MIL-PRF-19500/754B
w/AMENDMENT 3
9 February 2026
SUPERSEDING
MIL-PRF-19500/754B
w/AMENDMENT 2
9 October 2024

PERFORMANCE SPECIFICATION SHEET

SEMICONDUCTOR DEVICE, DIODE, SILICON, SCHOTTKY,
DUAL DIODE, COMMON CATHODE, DEVICE TYPE 1N7064,
SURFACE MOUNT PACKAGE,
QUALITY LEVELS JAN, JANTX, JANTXV, AND JANS

FIGURE 4. Avalanche energy test circuit.

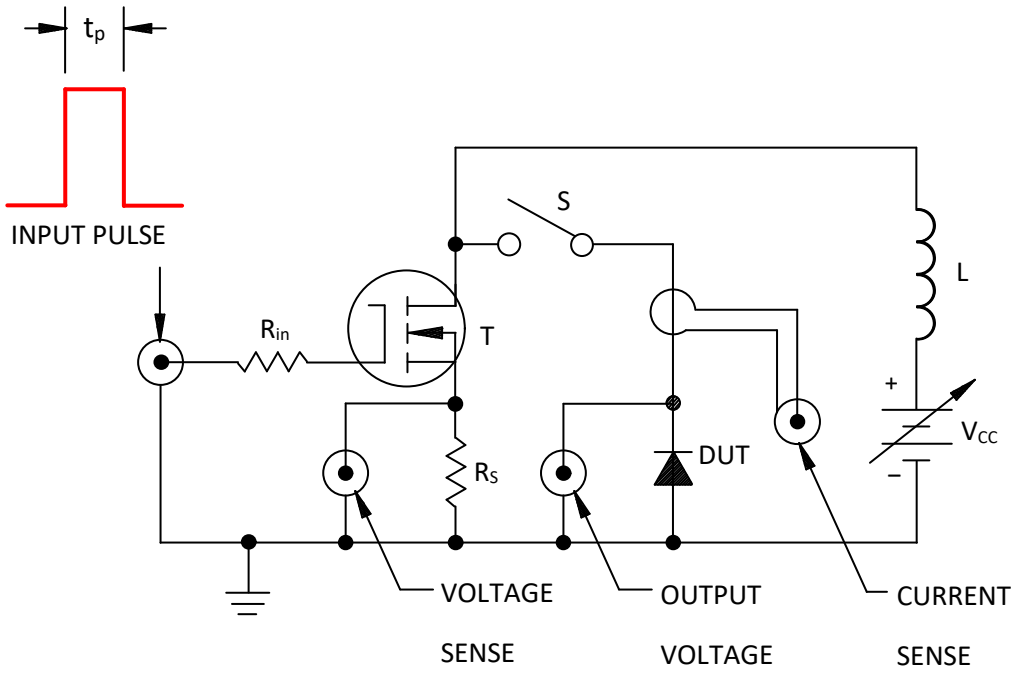
NOTES:
* 1. The following input pulse details shall apply: V_G = 10 Volts, P.W. $t_p \approx 30$ µs, duty cycle ≤ 1 percent.
2. The following test circuit component values shall apply: L = 100 µH, Z_G = 50 ohms, R_{in} = 50 ohms, 1 watt, R_S = 0.1 ohms, 1 watt, T = 2N6768 (IRF350 or equivalent).
3. The supply voltage $V_{CC} \approx$ 10 volts.
